STATE OF NORTH CAROLINA  
DEPARTMENT OF TRANSPORTATION

Subject: **Application/Project Narrative for CAMA Major Development Permit**  
for the replacement of Bridge No. 198 on SR 1172 over  
the Atlantic Intracoastal Waterway at Sunset Beach, Brunswick  
County. Federal Aid No. BRS-1813 (1), State Project No. 8.2230101,  
Division 3, TIP Project No. B-0682. Debit \$475.00 from WBS  
Element 32575.1.2.

## **PROJECT NARRATIVE**

PROJECT REFERENCE NO.	SHEET NO.
B-0682	5
RW SHEET NO.	
ROADWAY DESIGN ENGINEER	HYDRAULICS ENGINEER
INCOMPLETE PLANS DO NOT USE FOR R/W ACQUISITION	
PRELIMINARY PLANS DO NOT USE FOR CONSTRUCTION

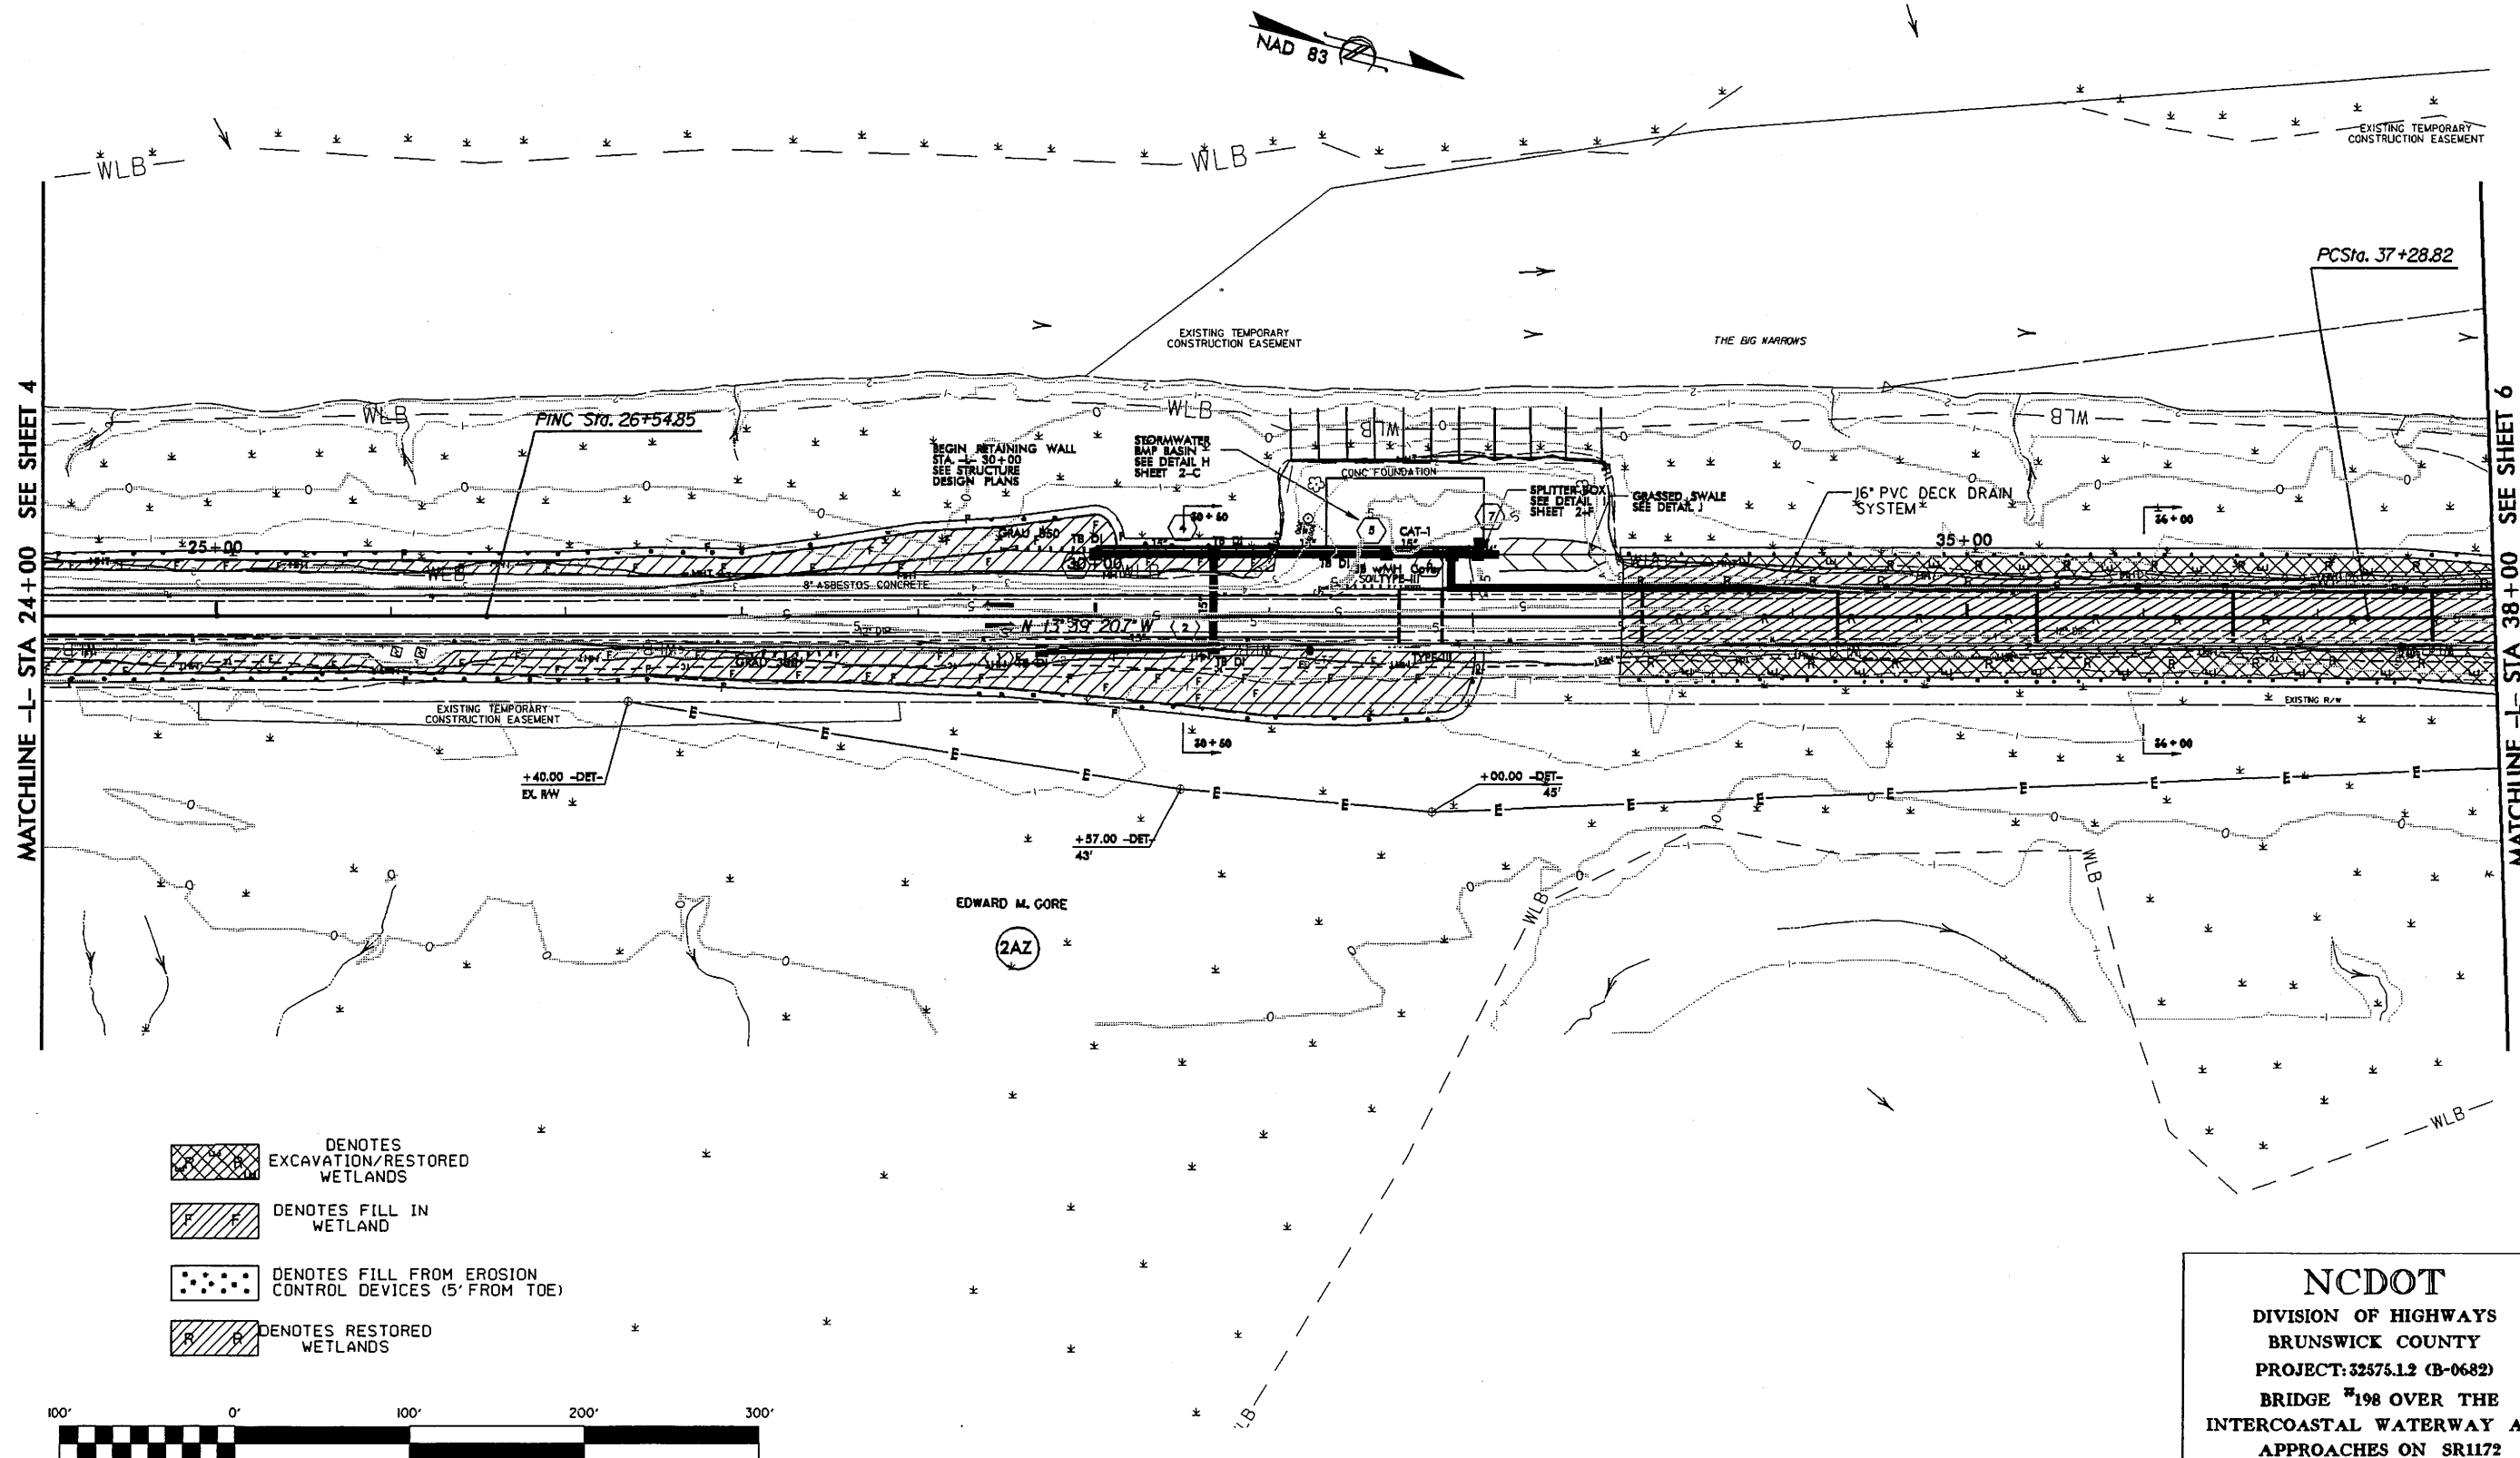
The bridge will begin at -L- Station 32+00. The permanent and or temporary impacts may change slightly when the bridge end bent design is finalized. Bill Arrington inquired as to why the stormwater basin could not be more centered on the upland area that it is to be constructed on. It was explained that the basin would be cleaned out from the westbound shoulder, and that the basin needed to be off-center to facilitate clean out.

PROJECT REFERENCE NO. B-0682		SHEET NO. 58	
ROADWAY DESIGN ENGINEER		HYDRAULICS ENGINEER	
INCOMPLETE PLANS DO NOT USE FOR ACQUISITION		PRELIMINARY PLANS DO NOT USE FOR CONSTRUCTION

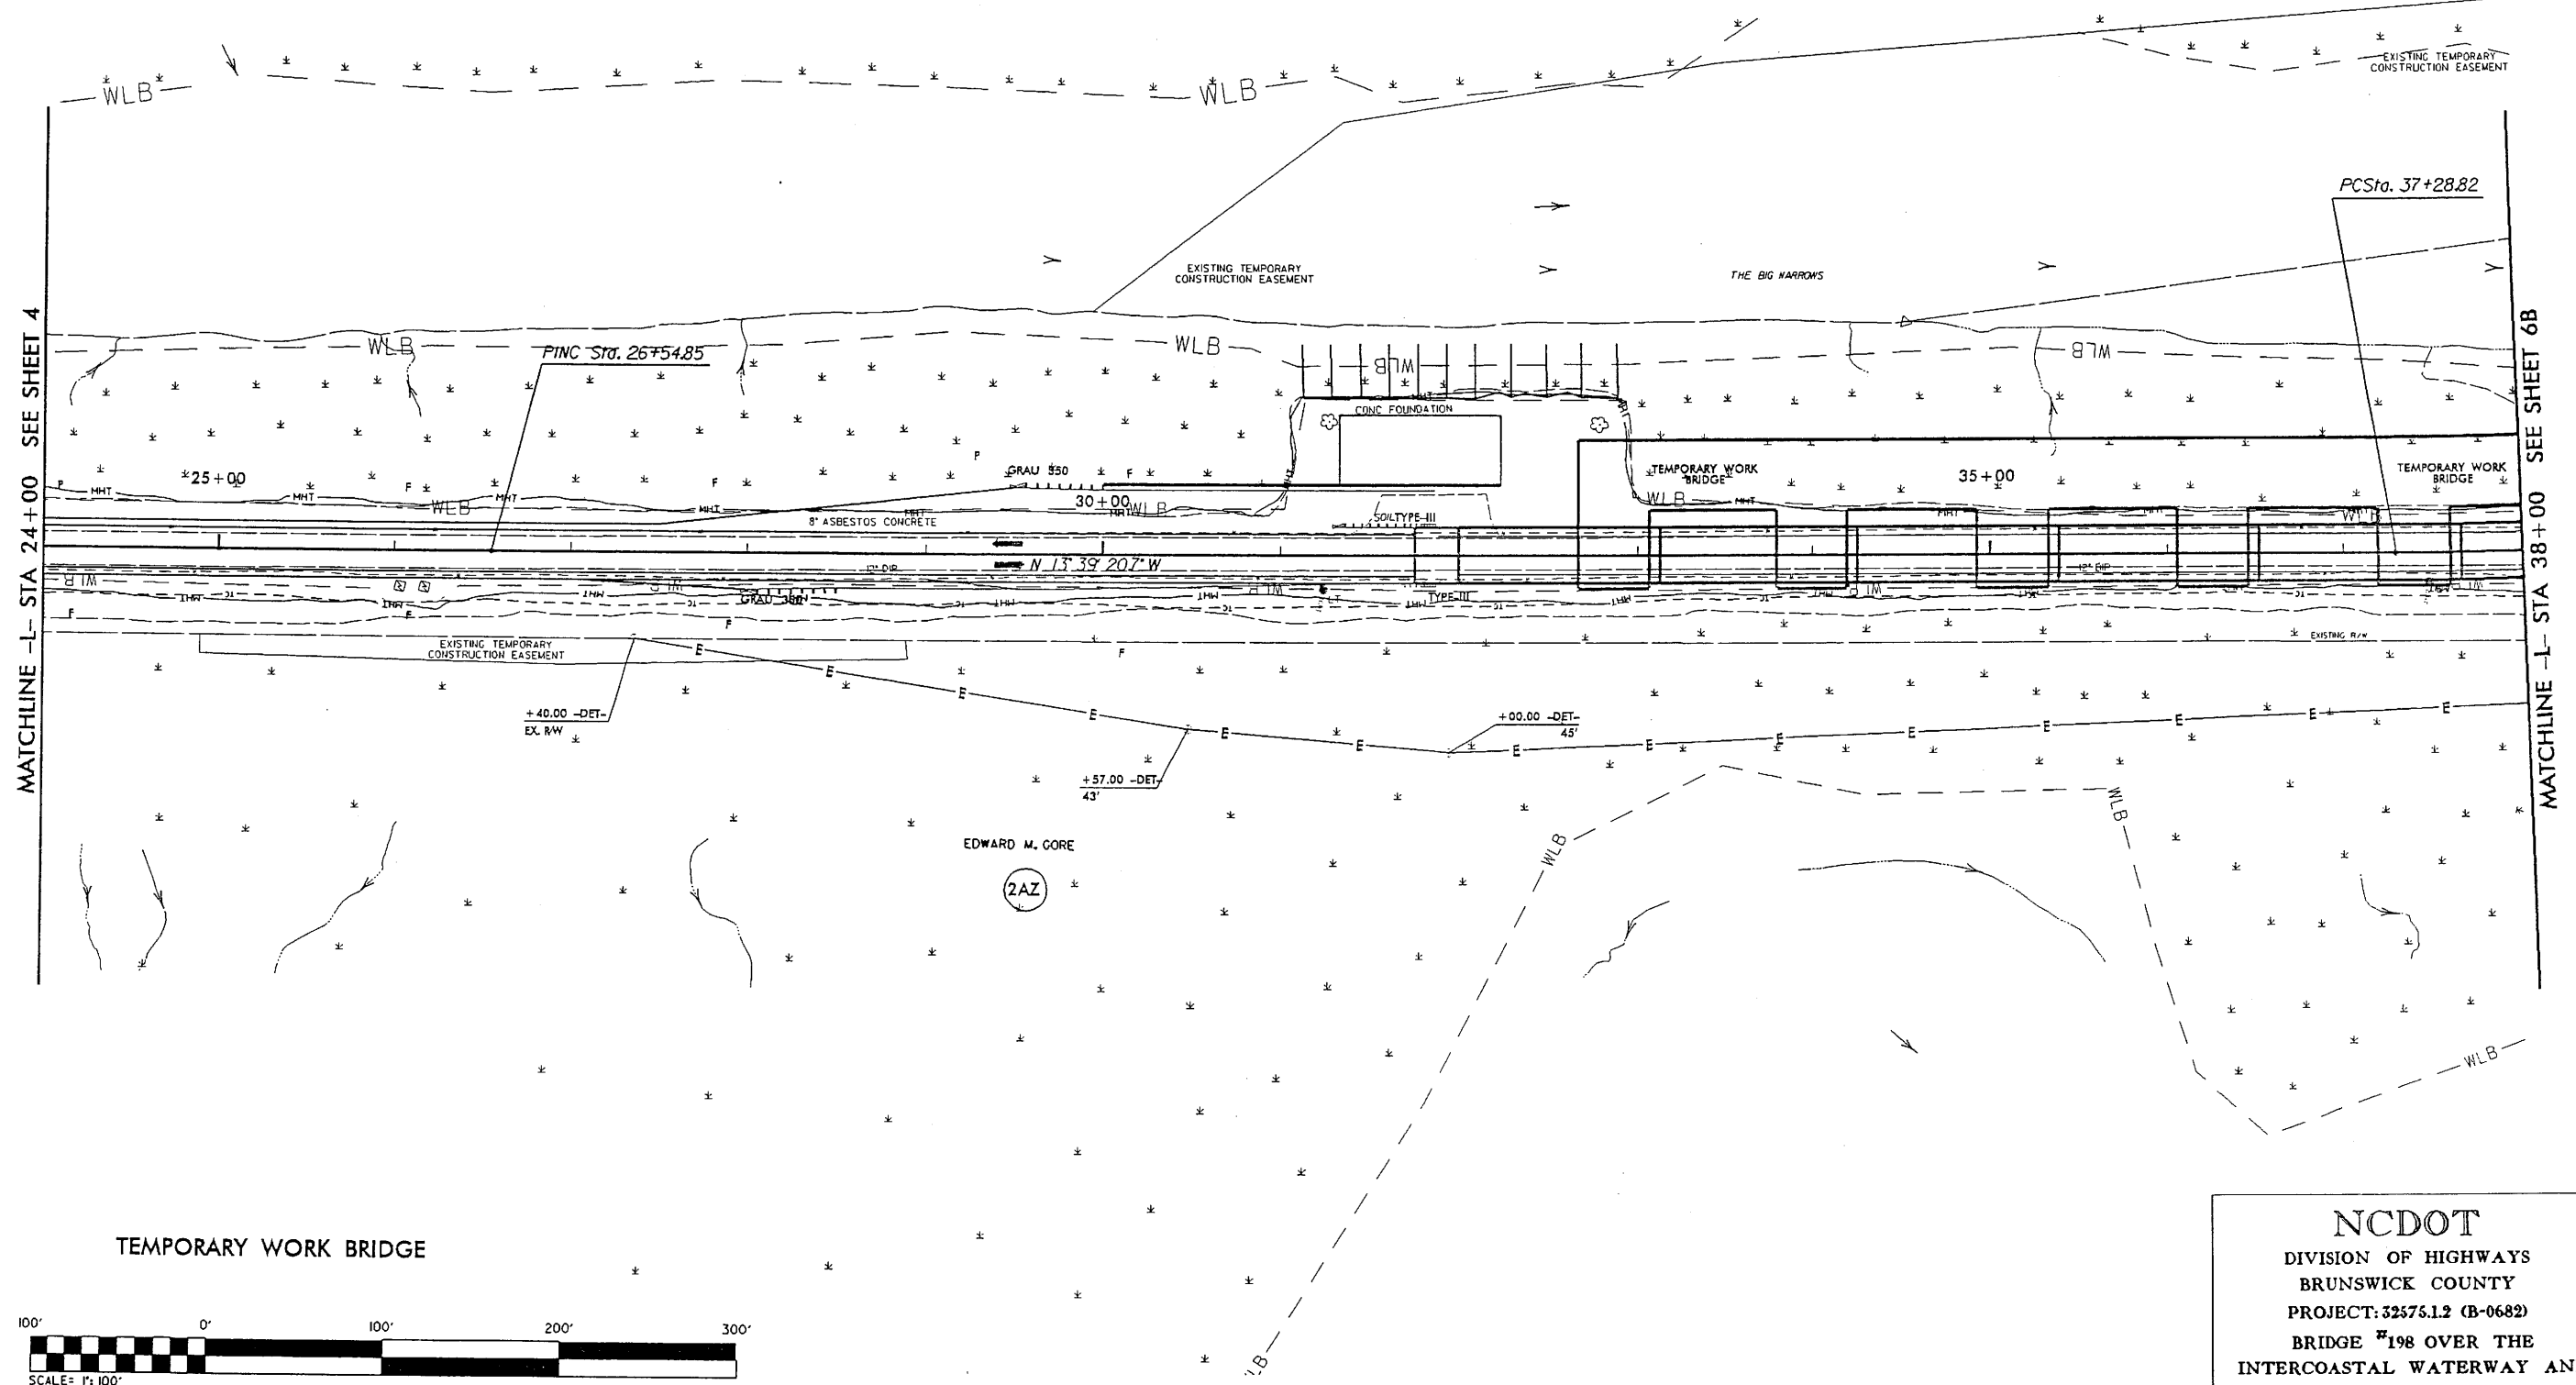
The location of the temporary bridge bents required for construction of the navigational span should be shown on the final permit impact sheets. The elevations of the footers and caps should be set at an elevation that can be constructed from the work bridge and that will not require excavation of wetlands for the form work. The agencies strongly emphasized that *the approved work bridge be designed to provide adequate access for all construction related activities and that request for permit modifications for other construction access that results in additional wetland impacts may not be approved unless the need is fully justified. The permit drawings*

*should include cross sections of the work bridge to insure that the structure can provide adequate construction access.*
